**JOINT ARCHITECTURAL BOARD/PLAN COMMISSION AGENDA**  
**MONDAY, JANUARY 19, 2015**  
**7:00 PM**  
**BOARD ROOM, MUNICIPAL BUILDING, 210 COTTONWOOD AVE.**

**VILLAGE OF HARTLAND  
JOINT ARCHITECTURAL BOARD/PLAN COMMISSION MINUTES  
MONDAY, DECEMBER 15, 2014  
7:00 PM  
BOARD ROOM, MUNICIPAL BUILDING, 210 COTTONWOOD AVE.**

**TO:** Plan Commission  
**FROM:** David E. Cox, Village Administrator   
**DATE:** January 16, 2015  
**SUBJECT:** Riverwalk PUD

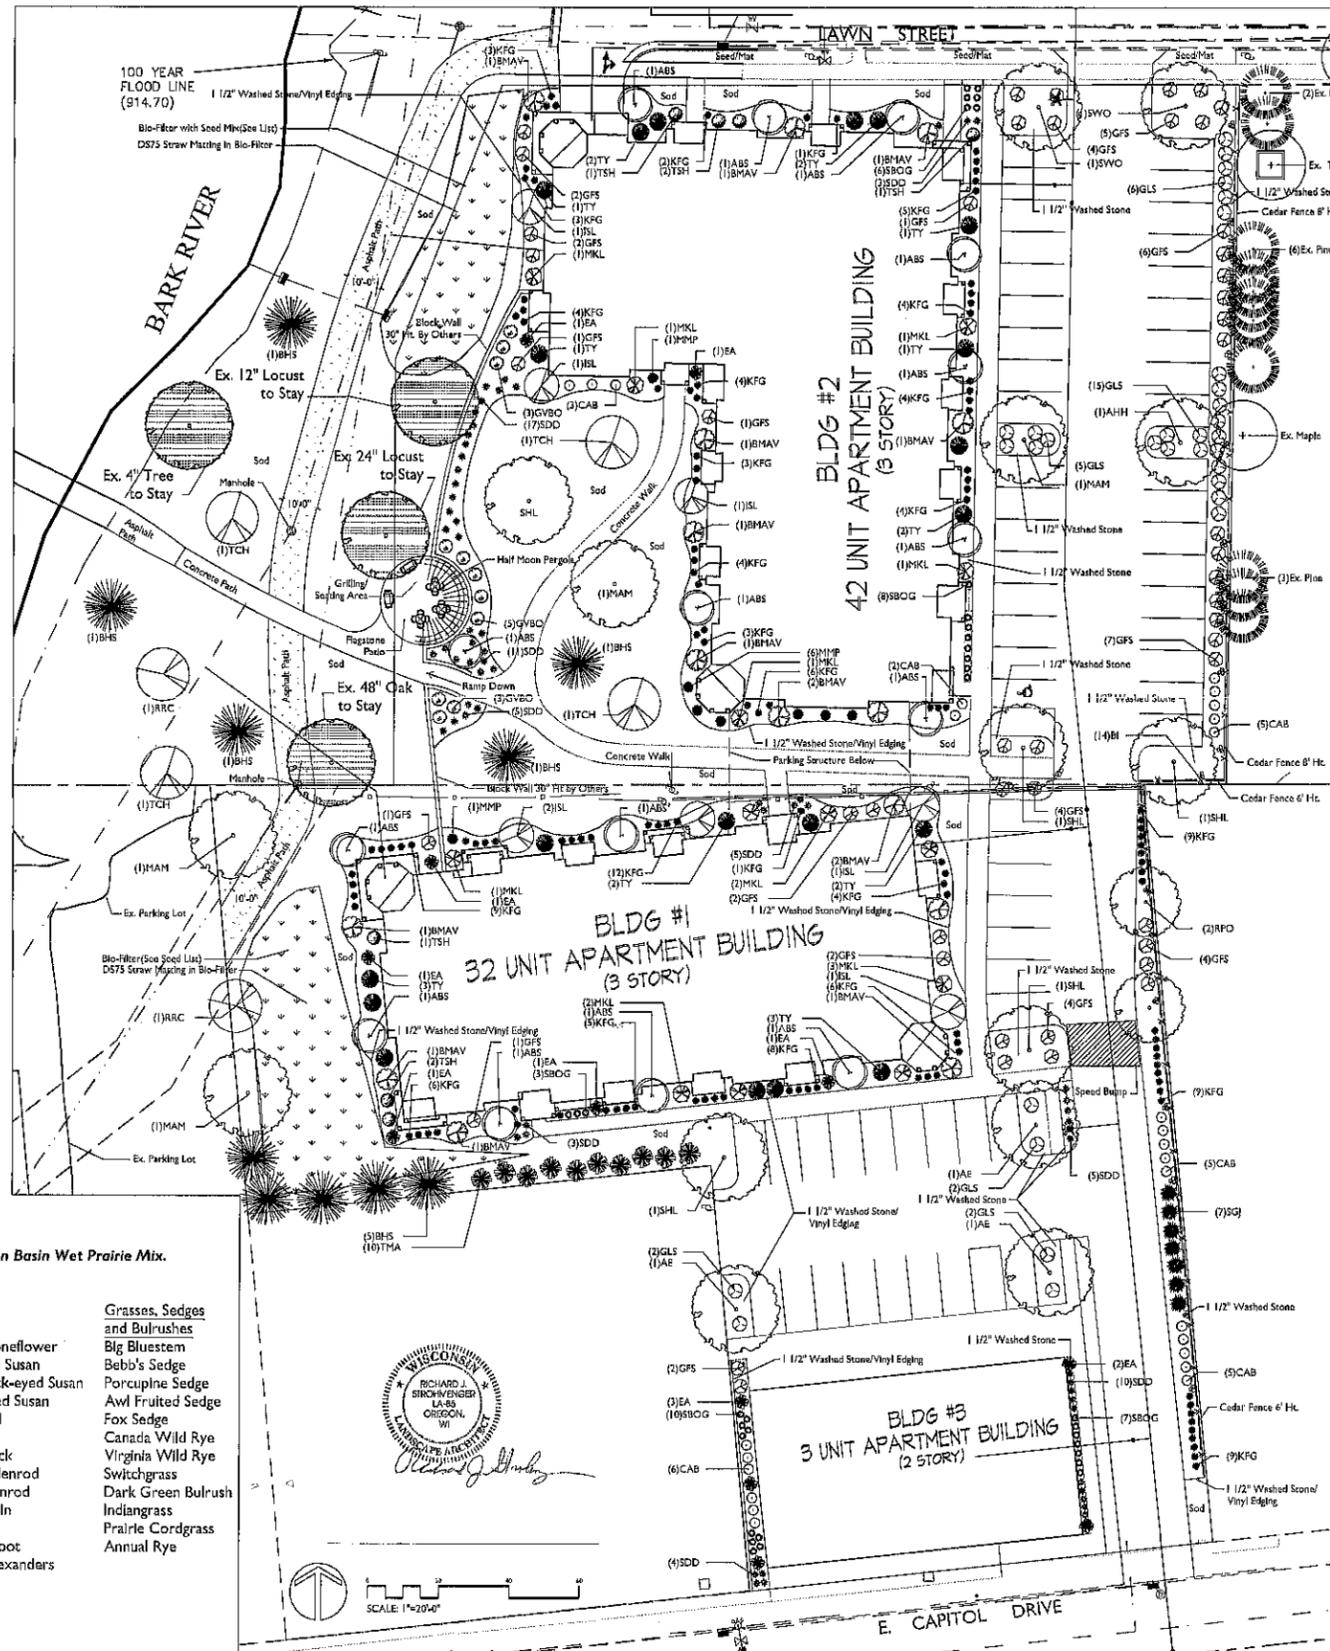
The Village would like to see what trees will be coming out. There is an oak tree near the south property line of the residential property on Oak Street that should be protected during construction.

- A finalized lighting plan needs to be developed.
- Show a definitive plan for the fence along the east side as well as overall landscaping.
- Revised Landscape Plan should address the saving of quality mature trees and clearly identify the mature trees to be removed.

Hartland, Wisconsin  
SHEET TITLE  
Site Plan

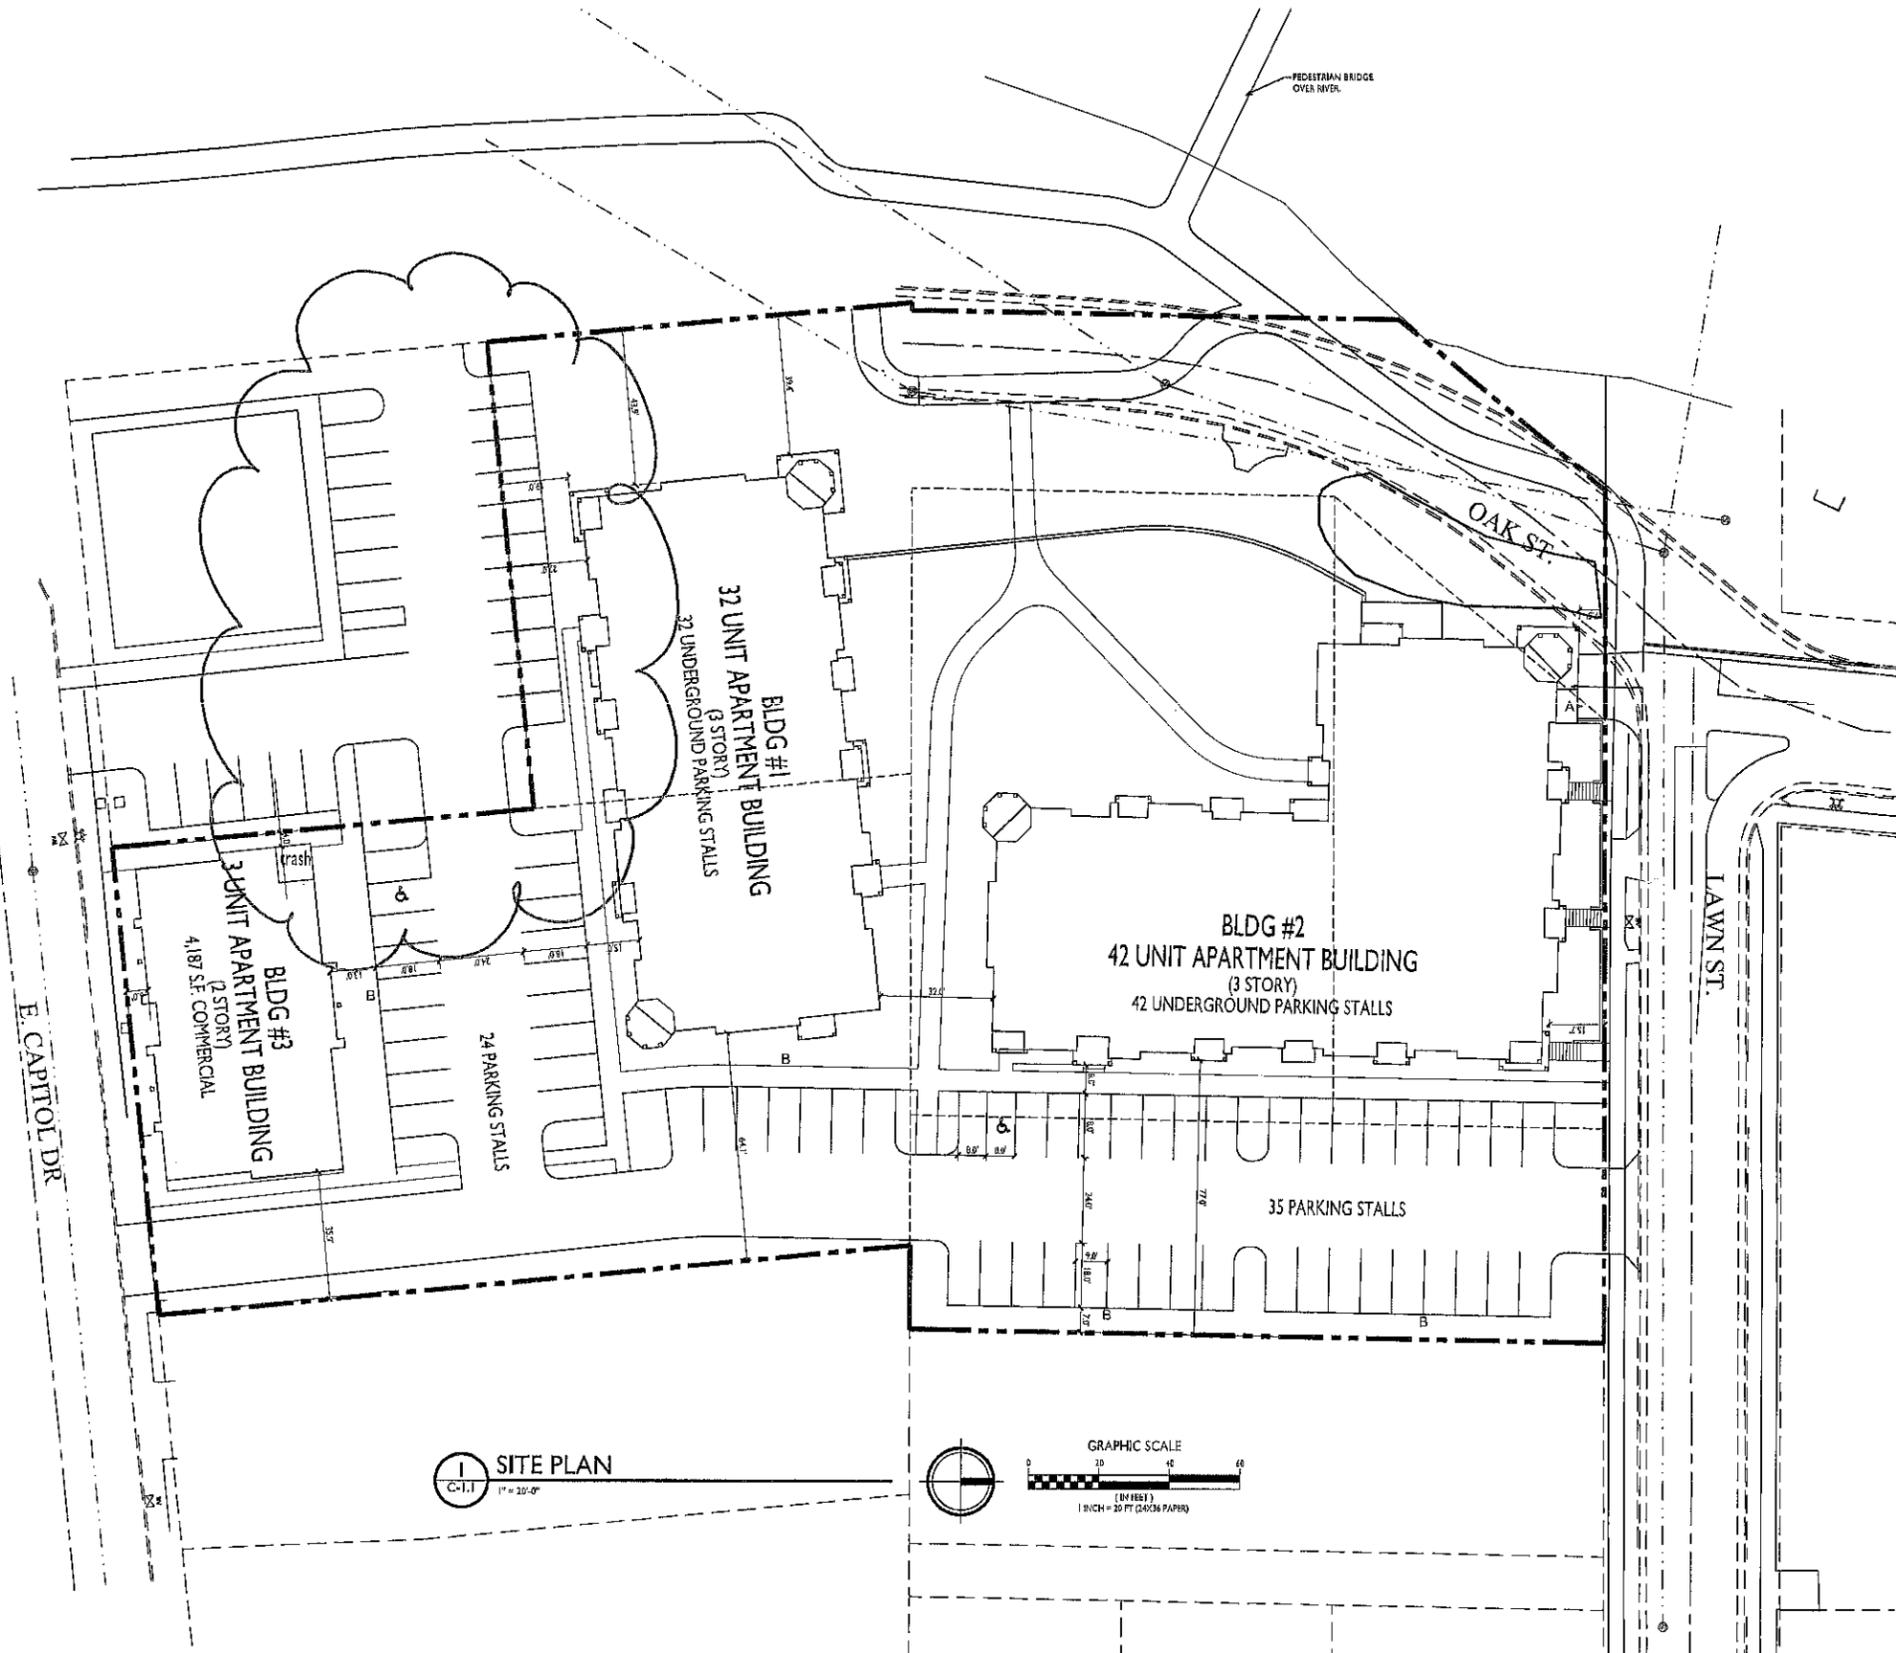
Administrator Cox told Mr. McCormick that his designer needs to spend additional time on the area of the Lawn Street intersection and the underground garage entrance/exit to ensure a smooth traffic flow.

The Village will need to verify the parking space size and also verify the number of spaces. Some of the stalls are a little small and there may not be enough buffering next to walls or stairwells, in particular around the mechanical room door. There doesn't seem to be room to open the door.

The Plan Commission agreed that 133 spaces should be enough parking for the development. However, staff will need to look at the 74 underground spaces to make sure they are realistic. There is some concern that they are all usable spaces.

Staff recommends two speed devices (speed tables) to help slow traffic from both ways in the course of the parking lot through-way.
